**Timbers at Black Forest
Letter of Intent**

26-16

File No.: SF26XX

Tax Schedule No: 5222000025
Acreage: 55.707 acres
Current Zoning: RR-5 (Residential Rural)
Requested Zoning: RR-2.5 (Residential Rural)

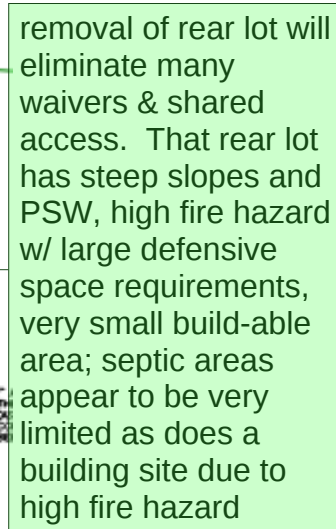
lot 12 may not meet fire protection report requirements with home and septic due to constraints to be mapped.

Brainstorming to help illustrate staff comments (not direction)

removal of rear lot will eliminate many waivers & shared access. That rear lot has steep slopes and PSW, high fire hazard w/ large defensive space requirements, very small build-able area; septic areas appear to be very limited as does a building site due to high fire hazard
